Subject: Schematic Condition Assessment – 450 E. Belmont Avenue, Fresno CA
North and South Buildings

Project: 450 E. Belmont Avenue
Project No.: 16653

N
22

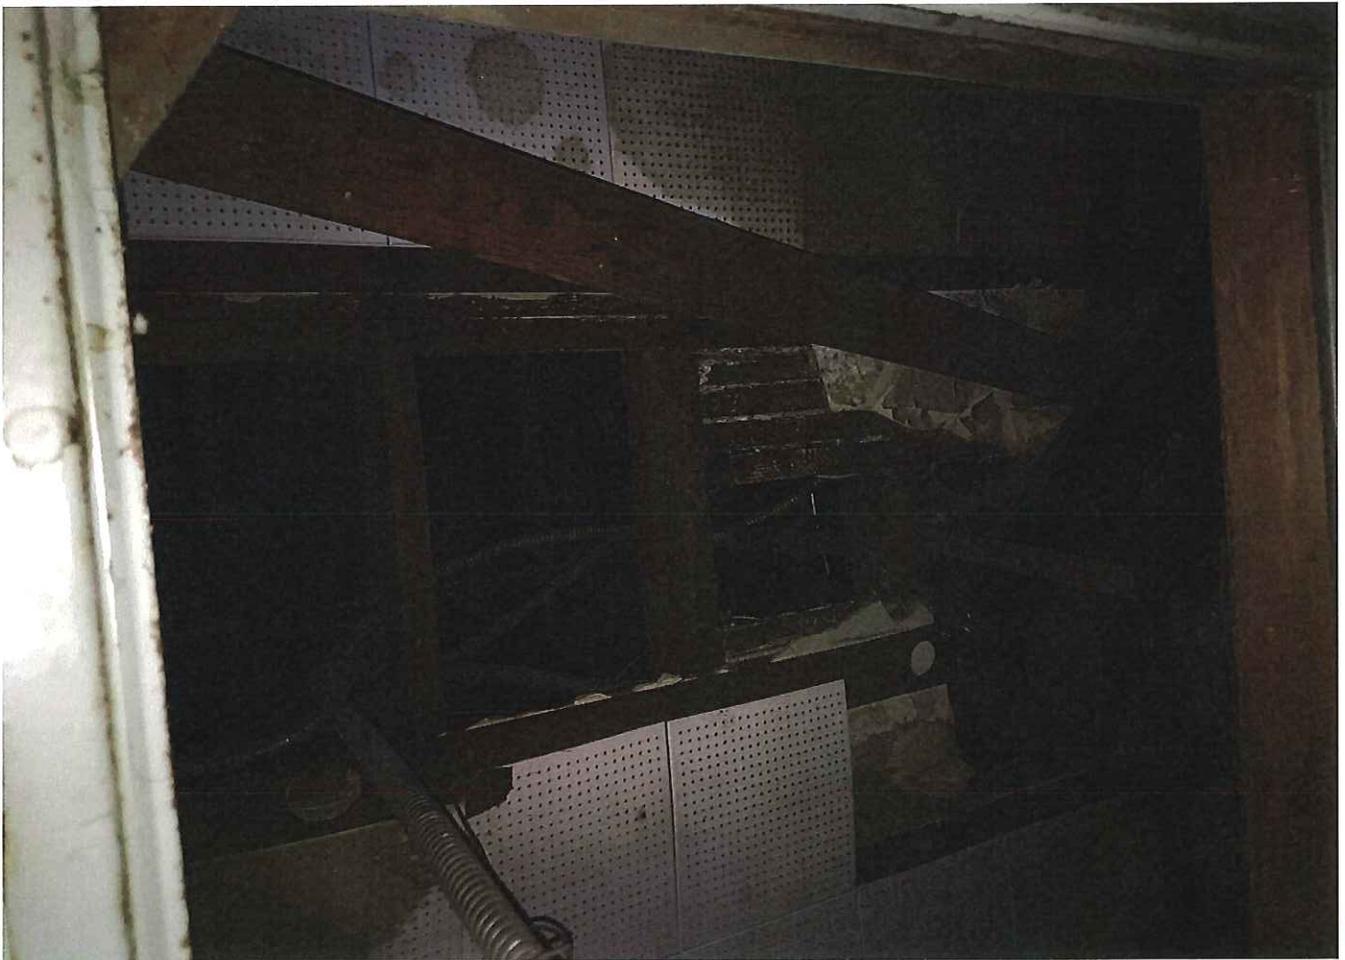
- Steel moment frames resisting lateral forces in same principal direction as solid masonry walls. (Photo N9)
- Nominally reinforced CMU walls. (Photo N22)

N
25

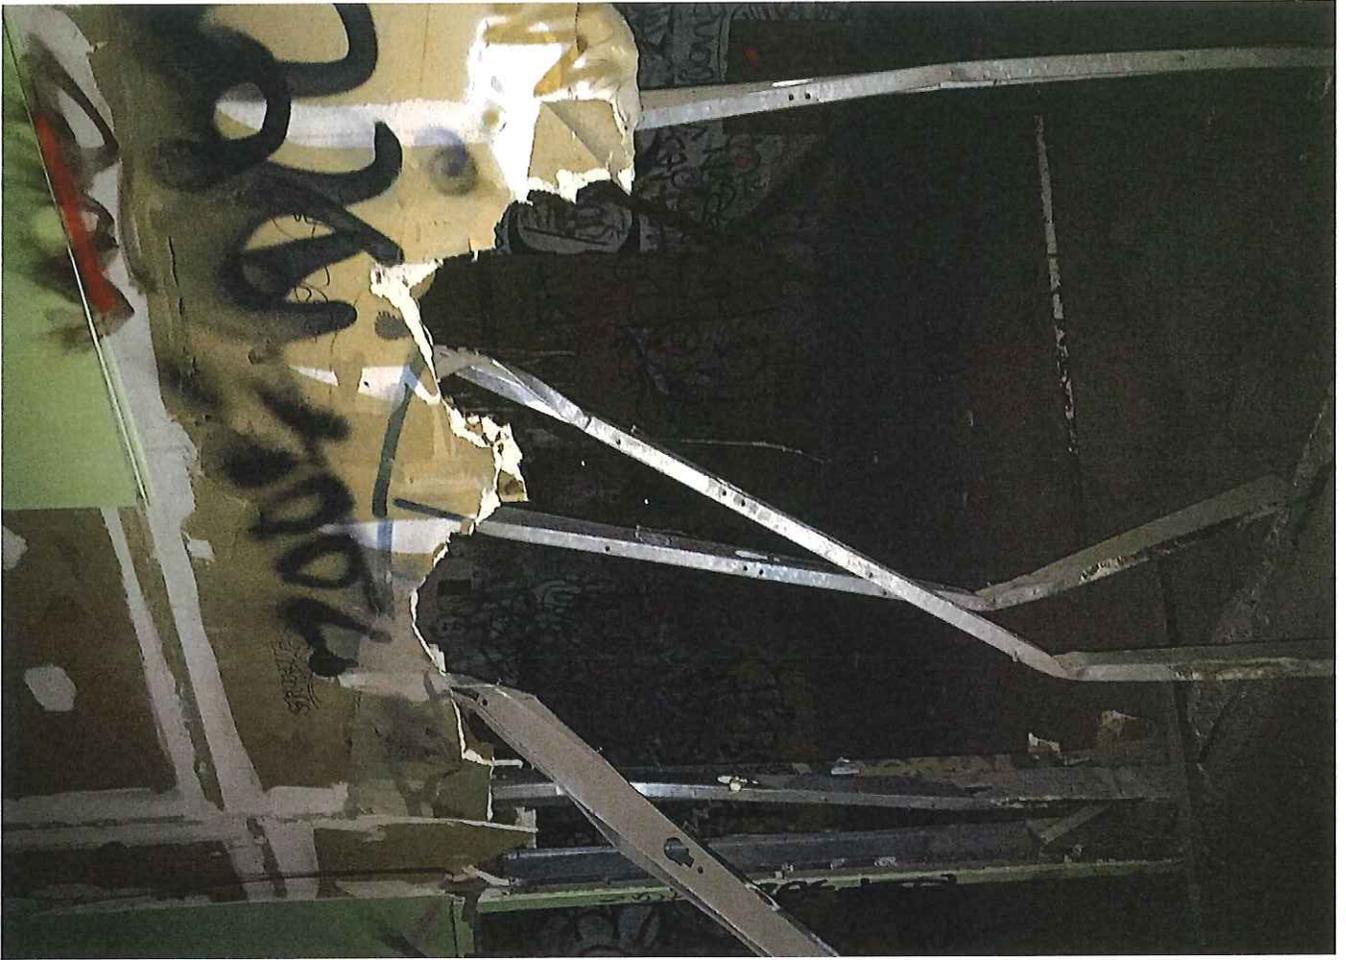
- West wall above moment frame is a diagonally sheeted wood wall with a plater finish on the outside. (Photo N9)
- Straight wood board diaphragms exist in several areas of the building. (Photo N25)

- Seriously damaged roof sheeting was observed in several areas of the building. (Photo N25)
- There appears to be at least 3 major phases of construction. The nature of these separate phases seem to lack a coordination with the previous construction resulting in a lack in continuity and connection of the subsequent phases so as to provide a total building which will act as a whole during exposure to wind or seismic forces. (Photo N29)

N
37

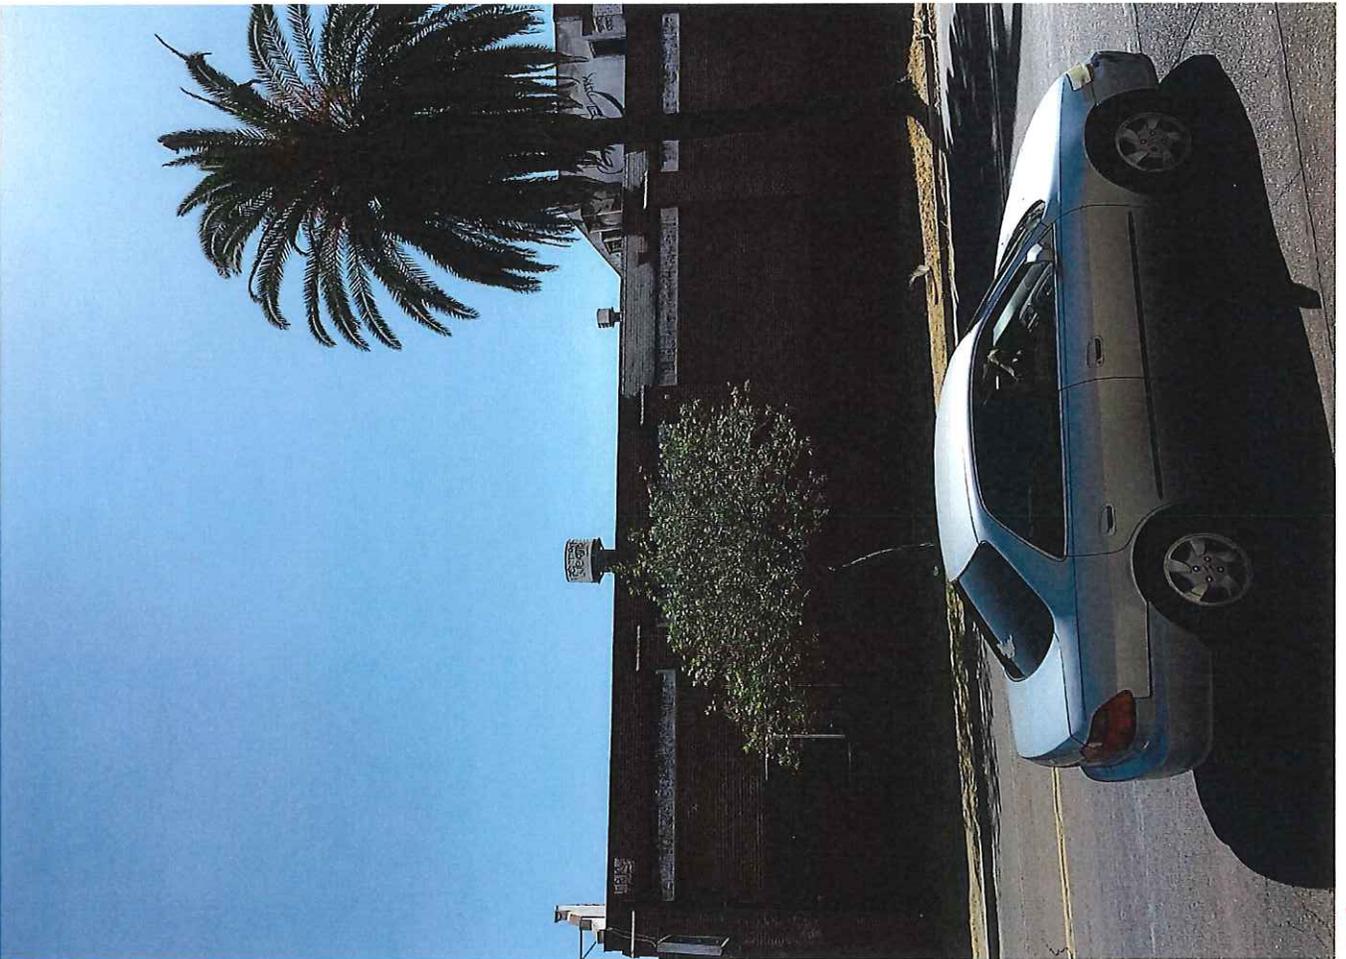
- A mixture of Unreinforced Red Brick walls, wood stud walls, and light gage metal stud walls apparently all working as shear walls.
- Tall unreinforced red brick perimeter walls (Photo N37)
